Sequoyah Nuclear Plant, Unit 1 and Unit 2
Facility Operating License No. DPR-77 and DPR-79
NRC Docket No. 50-327 and 50-328

Subject: Completion of Required Action by NRC Order EA-12-051, Reliable Spent Fuel Pool Instrumentation

**ENCLOSURE 2
SEQUOYAH NUCLEAR PLANT, UNITS 1 AND 2**

**RESPONSE TO THE NRC REQUEST FOR ADDITIONAL INFORMATION REGARDING
OVERALL INTEGRATED PLAN FOR RELIABLE SPENT FUEL POOL INSTRUMENTATION**

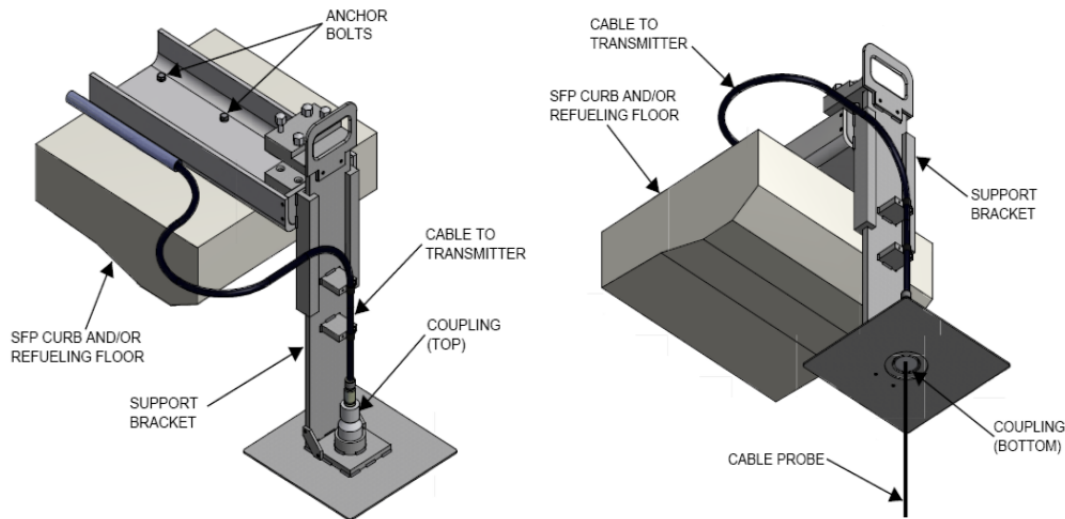
- a) The design criteria used to estimate the total loading on the mounting device(s), including static weight loads and dynamic loads. Describe the methodology that will be used to estimate the total loading, inclusive of design basis maximum seismic loads and the hydrodynamic loads that could result from pool sloshing or other effects that could accompany such seismic forces.*
- b) A description of the manner in which the level sensor will be attached to the refueling floor and/or other support structures for each planned point of attachment of the probe assembly. Indicate in a schematic the portions of the level sensor that will serve as points of attachment for mechanical/mounting or electrical connections.*
- c) A description of the manner by which the mechanical connections will attach the level instrument to permanent SFP structures to support the level sensor assembly.*

- b) The level sensor cable assembly is suspended from a support bracket, which is secured to the refueling floor and/or spent fuel pool curb using concrete anchor bolts. The level sensor cable suspended in the SFP is attached to a threaded coupling, which is secured to a support bracket. The cable leading to the transmitter is also attached to the threaded coupling. **See Attachment 1, Item 12.** The generic illustrations below depict these attachments.

SQN Plan View of SFP Area - Response to RAI #1

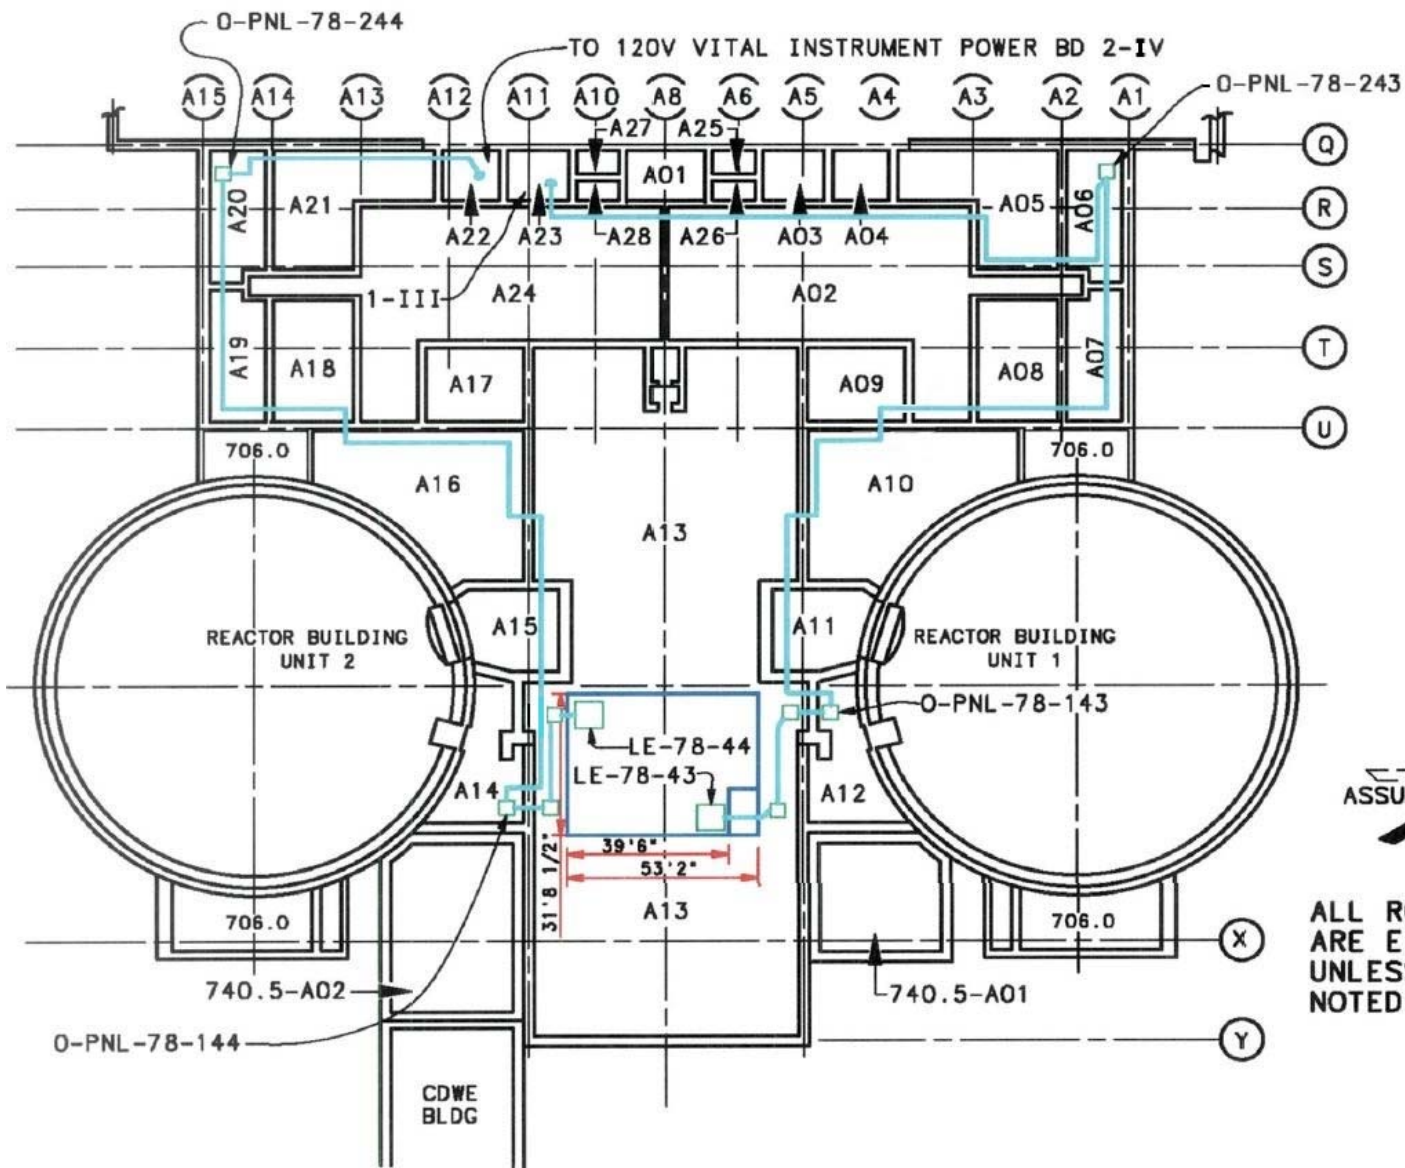
Please provide a clearly labeled sketch or marked-up plant drawing of the plan view of the SFP area, depicting the SFP inside dimensions, the planned locations/placement of the primary and back-up SFP level sensor and mounting brackets, and the proposed routing of the cables that will extend from the sensors toward the location of the read-out/display devices.

See Attachment 2 for plan view of the spent fuel pool (SFP) area, depicting the requested information.
